YEAR 5 MONITORING REPORT

UT TO NEUSE RIVER (BIG DITCH) STREAM RESTORATION SITE

RE: NCDEQ – Division of Mitigation Services
UT Neuse Stream Restoration Project
DEQ Contract Number: 005391
DMS Project Number: 92682
Response to DMS Review Comments on Draft Year 5 Monitoring Report for UT Neuse (Big Ditch)

FIGURE 2.1

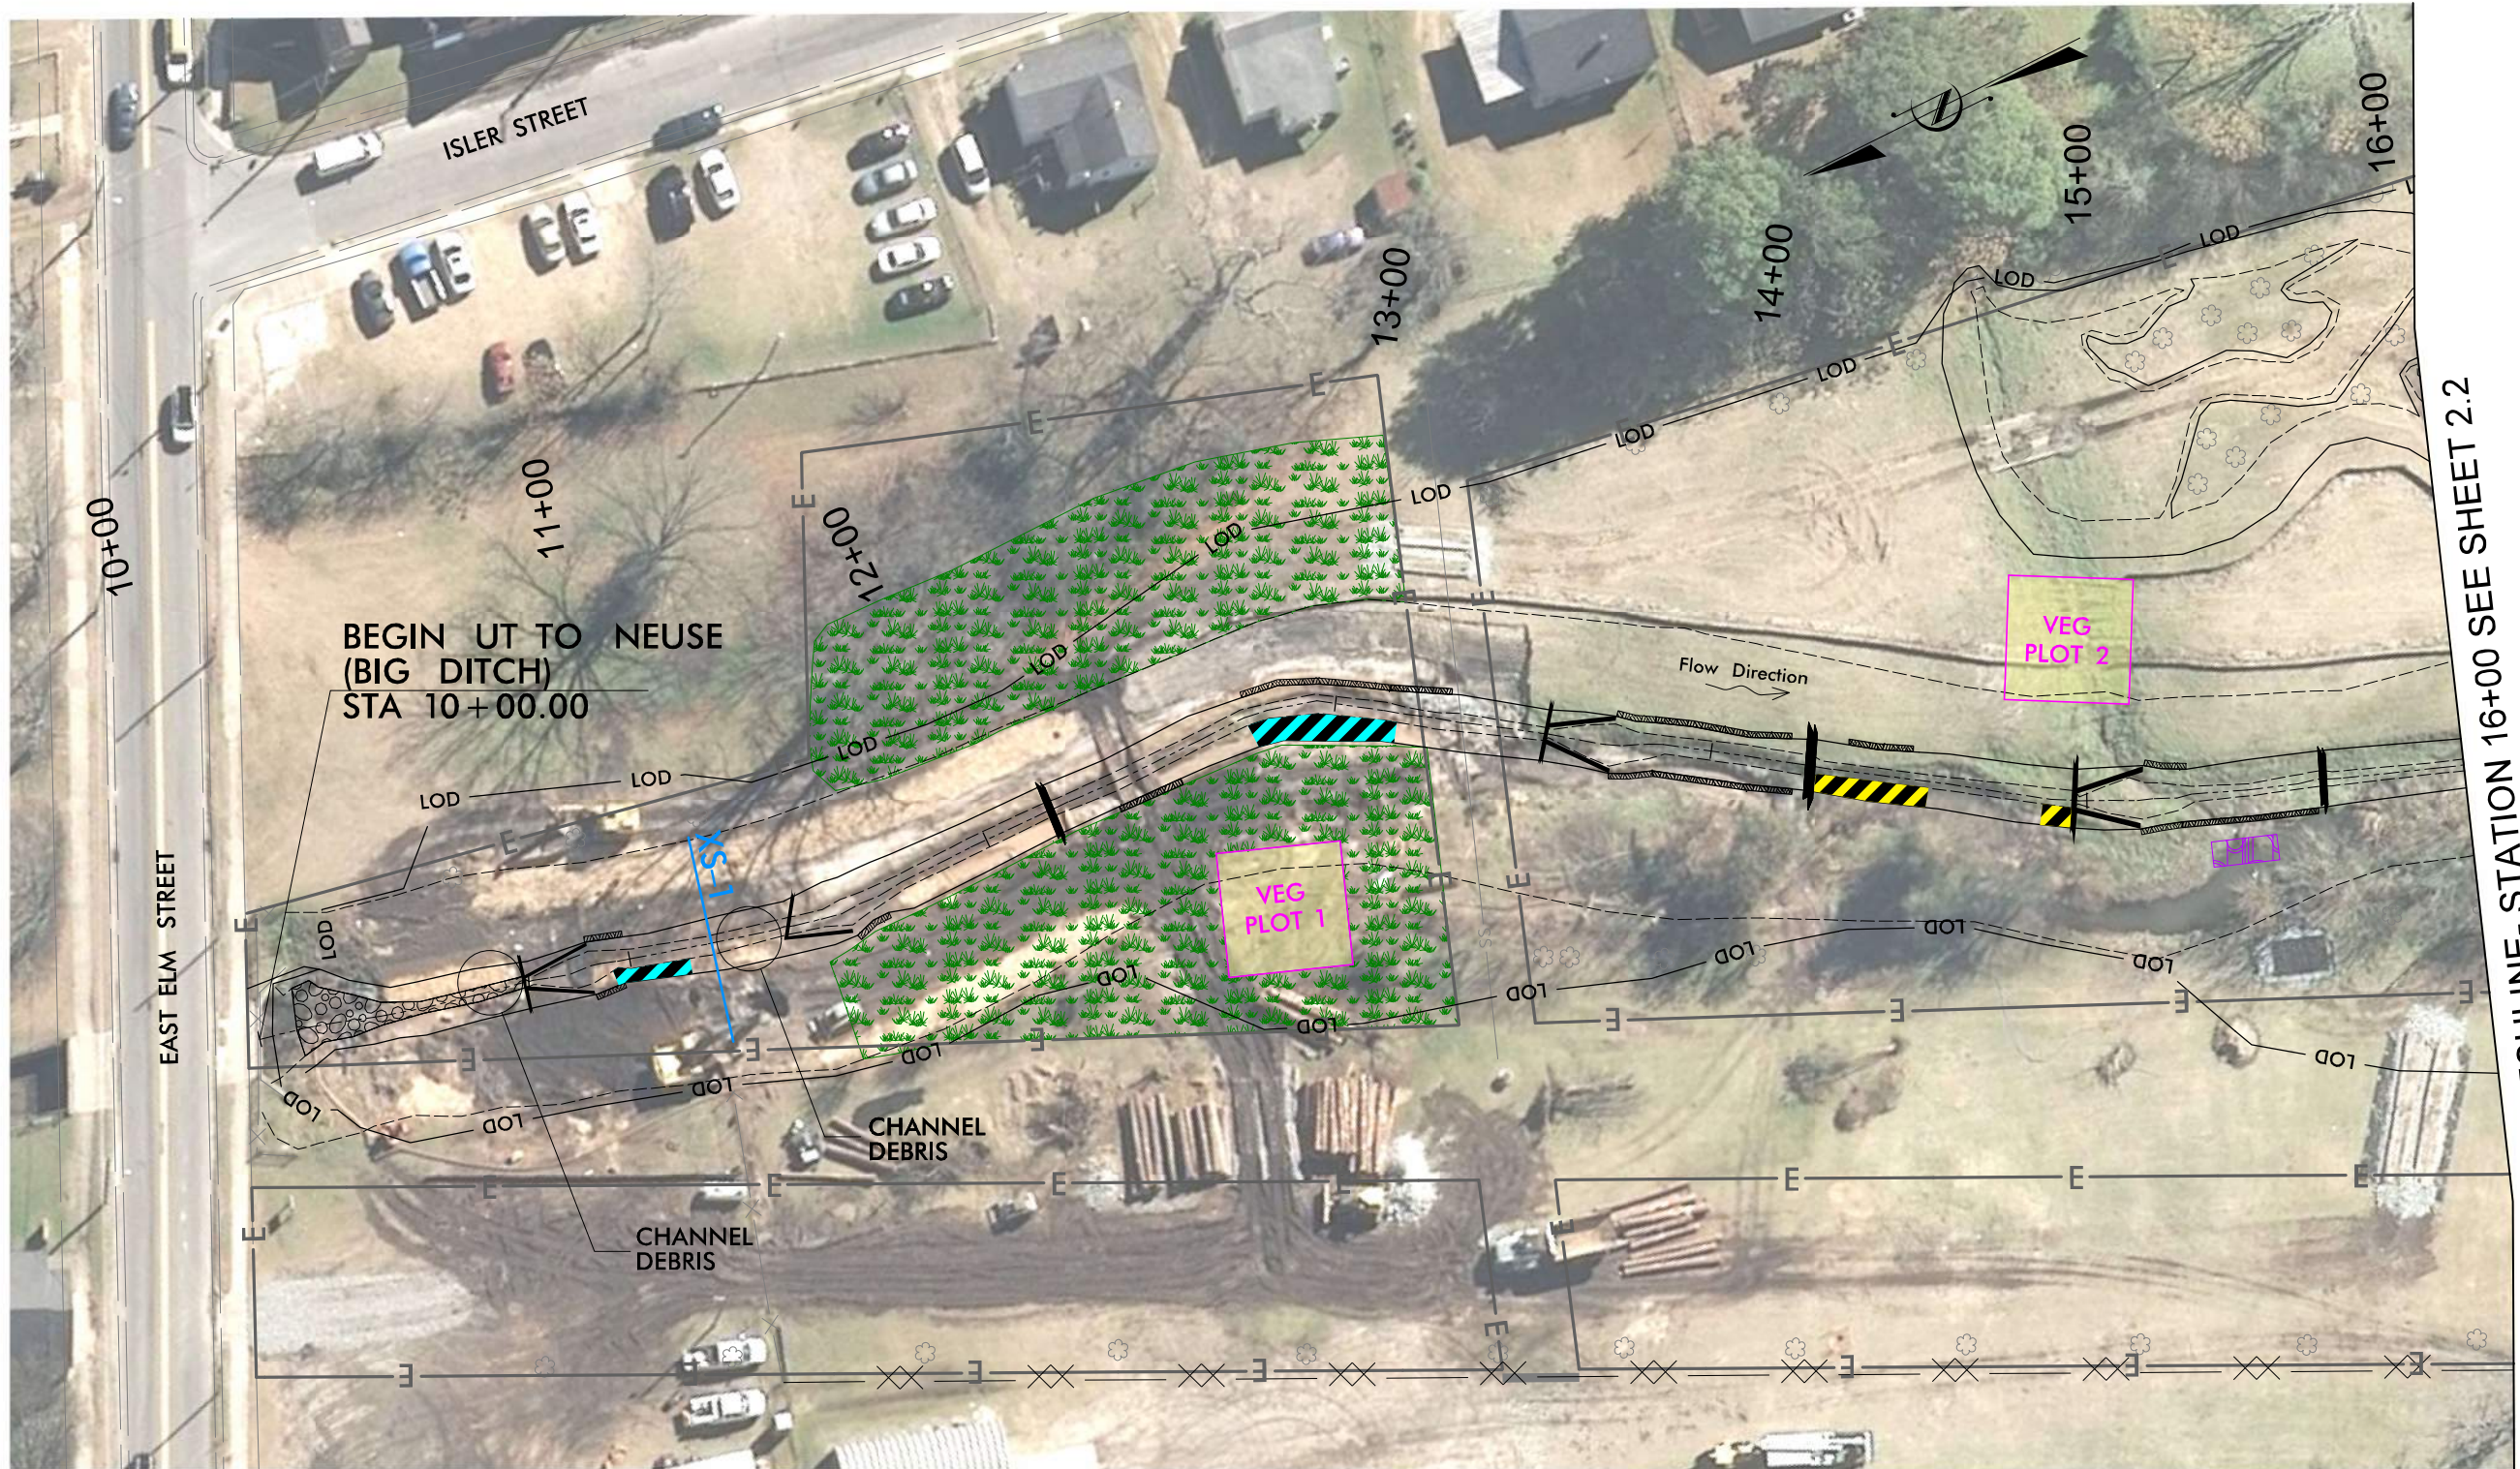
a. CCPV Figure 2.1 shows two fallen trees across the channel but there is no discussion in the report narrative regarding these trees or any impacts current or potential they might have on the projects. Clarify if they are causing or could potentially cause problems for this project.

b. In addition, during an October 10, 2018 site visit by DMS staff, it did not appear that these trees were laying across the channel. Either revise the figure showing the correct position of these trees or provide photos showing them across the channel.

The fallen trees have been removed from the CCPV.

The fallen trees have been removed from the CCPV.
